DRAINAGE SUMMARY

PROJECT: MAUNALOA HIGHWAY, REPLACEMENT OF CULVERTS BETWEEN
MAUNALOA VILLAGE AND KAUNAKAKAI - PHASE II
PROJECT NO. RS-0460(3)

STATE OF HAWAII
DEPARTMENT OF TRANSPORTATION
HIGHWAYS DIVISION

Replacement of Culverts bet. Maunaloa
Village and Kaunakakai - Phase II

DETAILS OF 36" CULVERT @ ± STA. 93+20

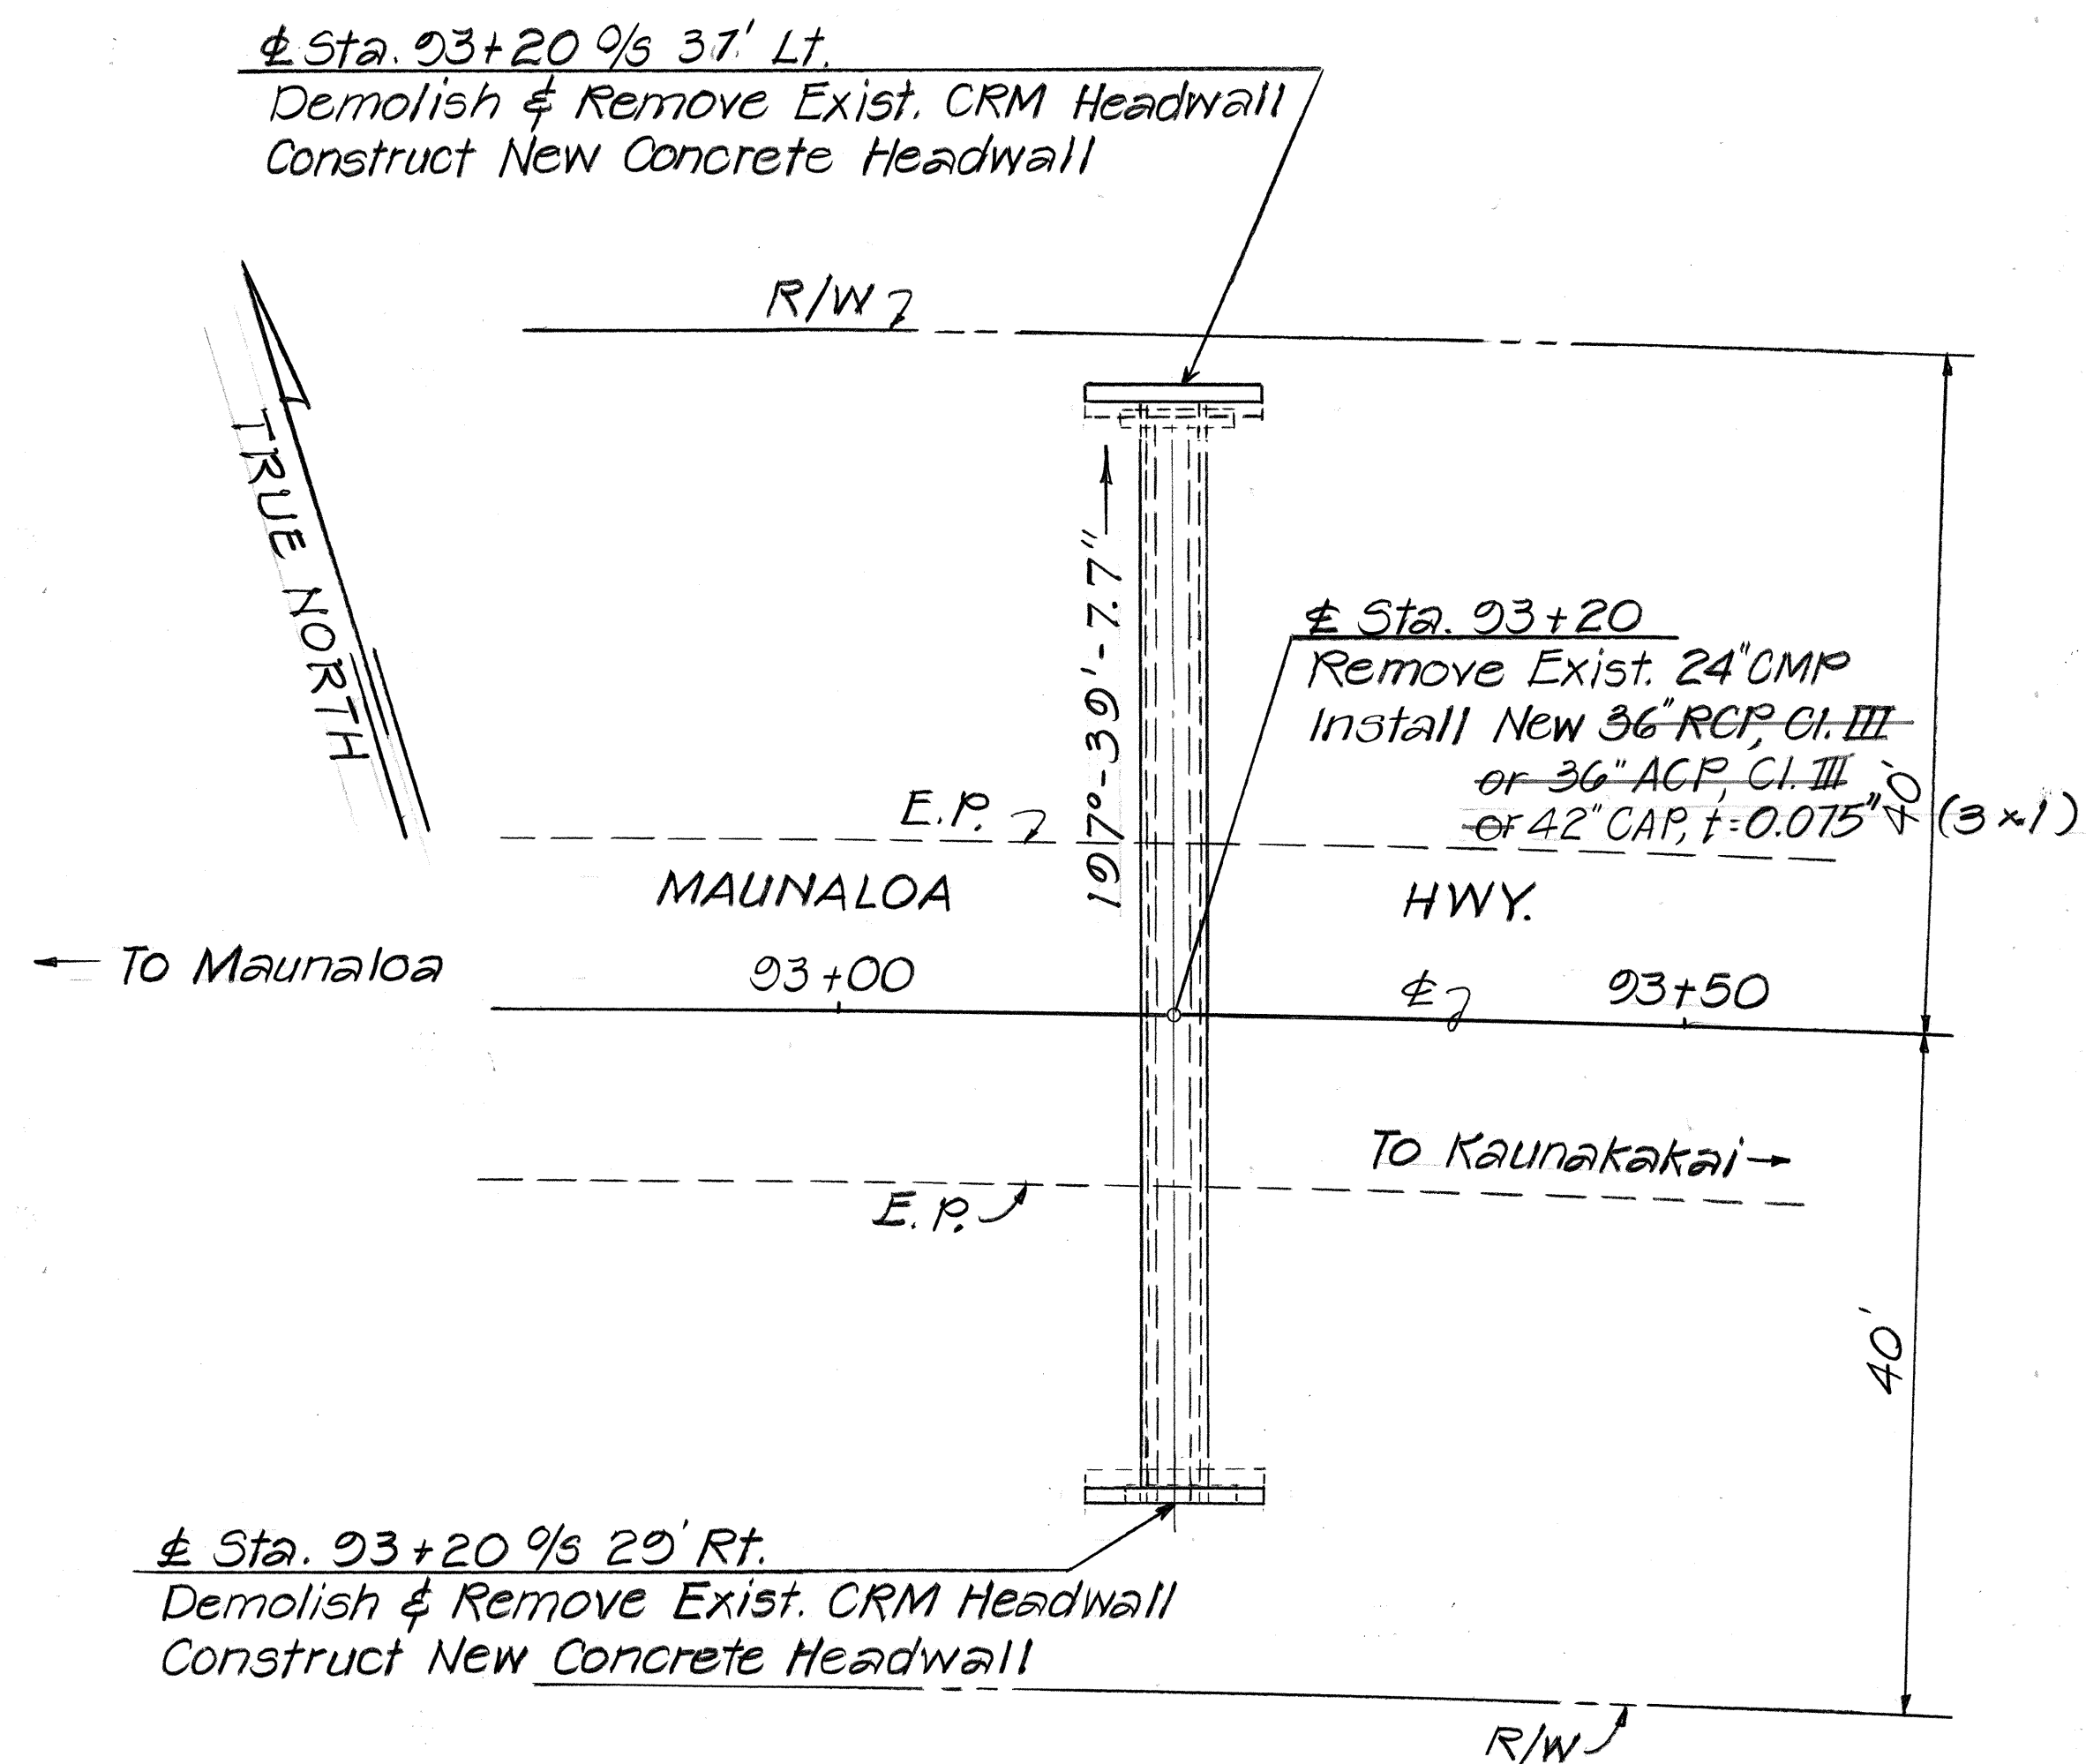
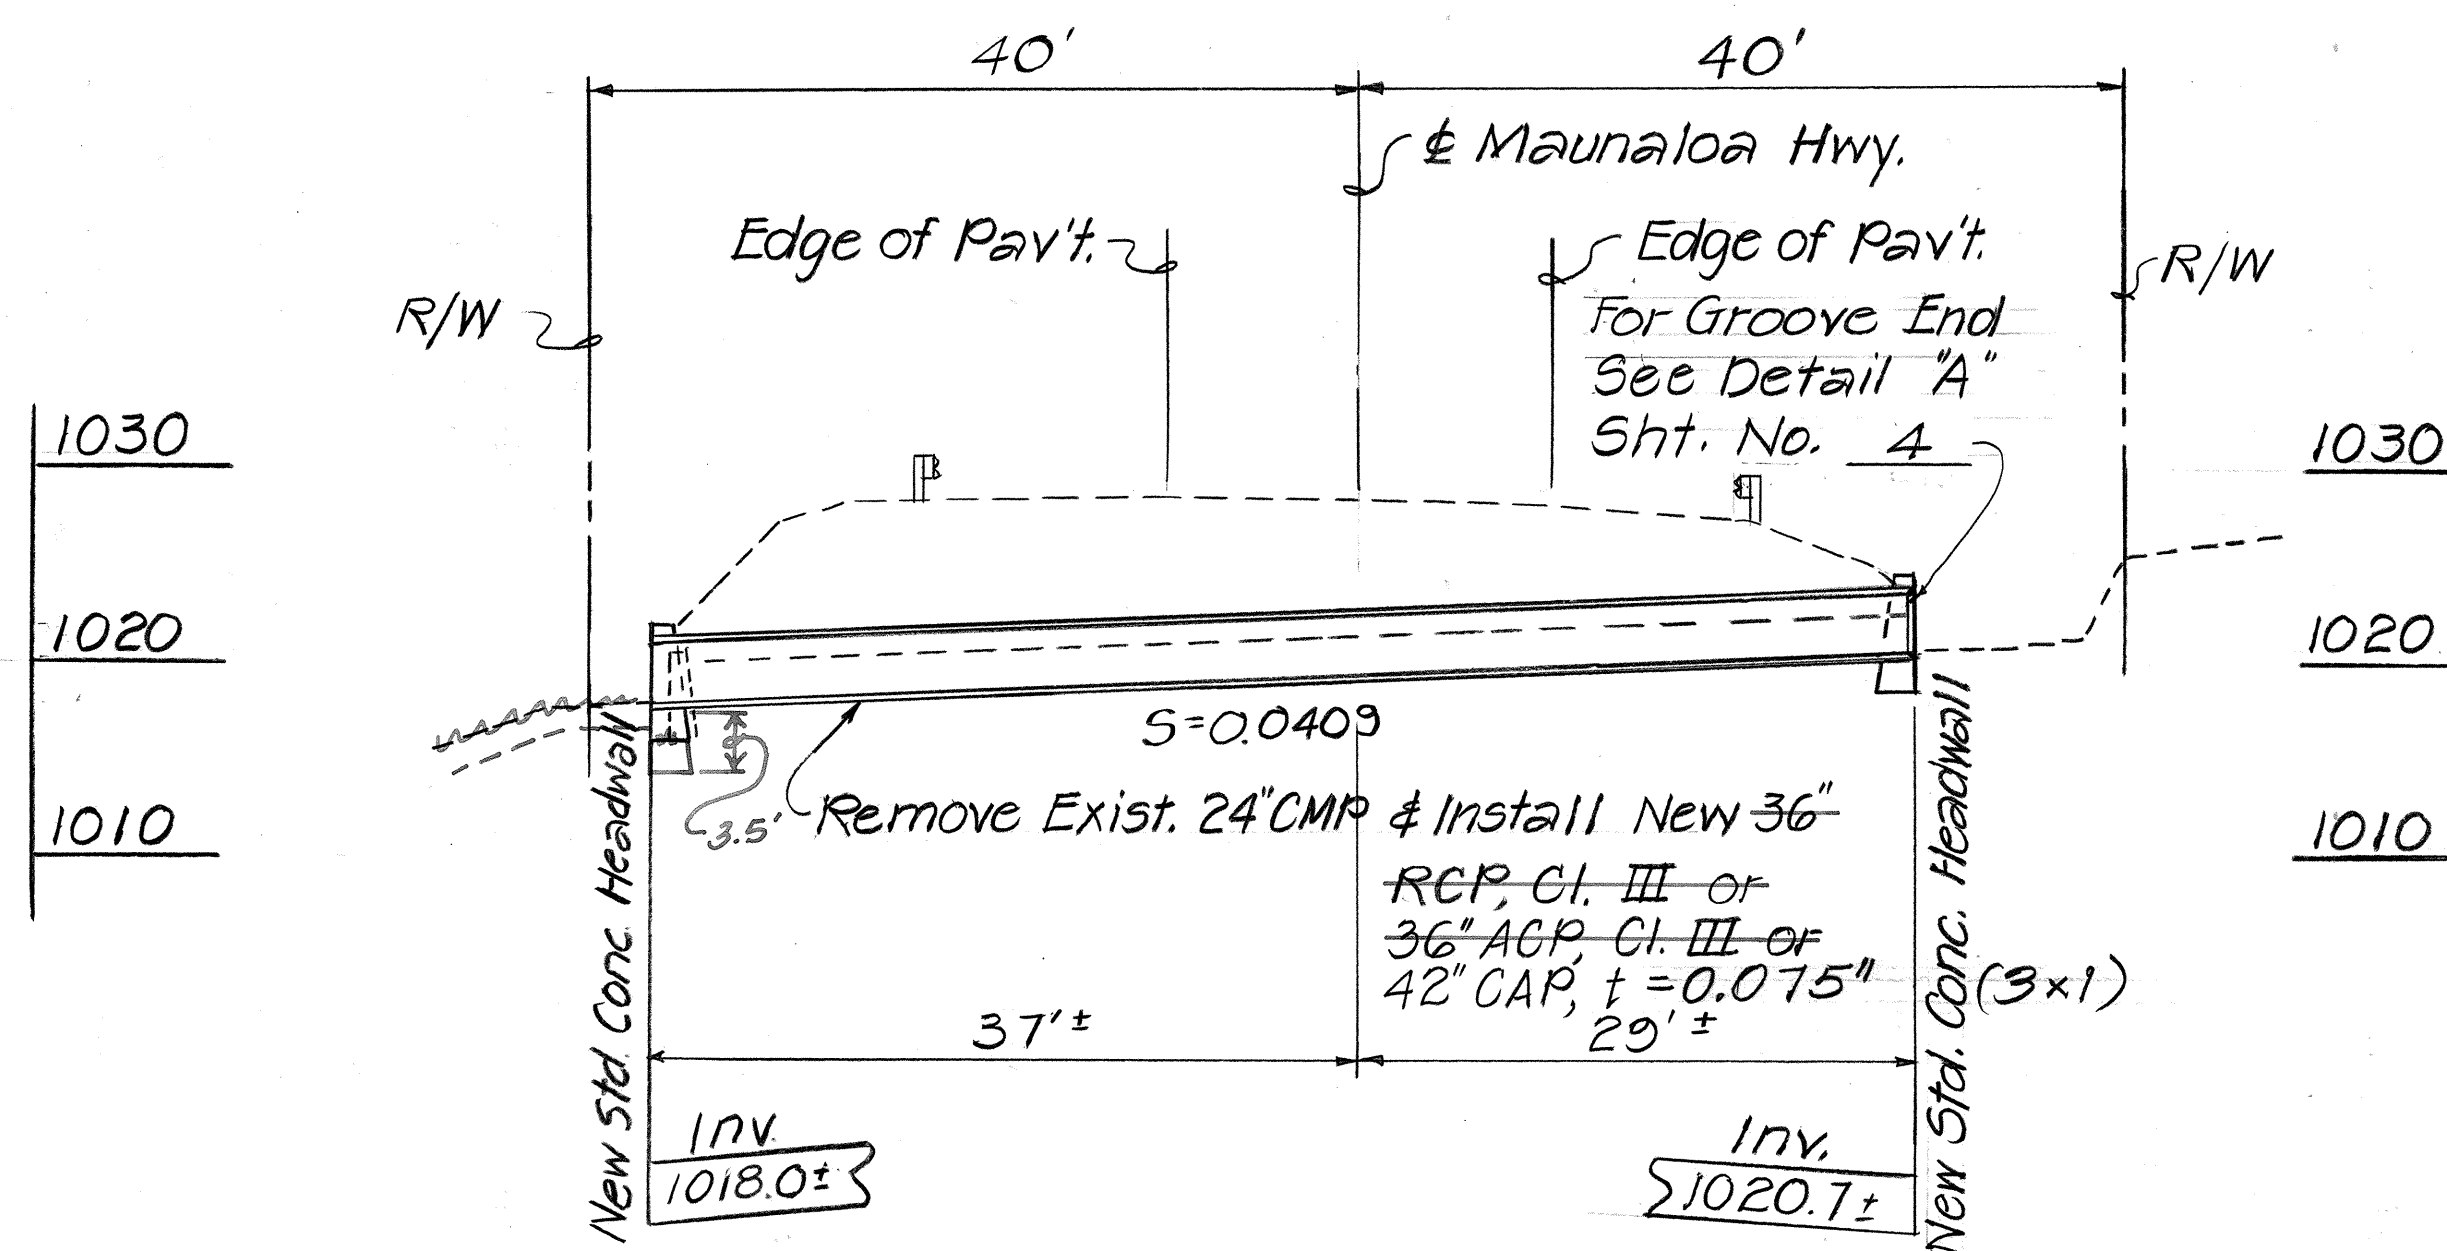
10/23/84 Per Addendum No. 1
Changed 42" CAP, t=0.105" to 42" CAP, t=0.075" (3x1)
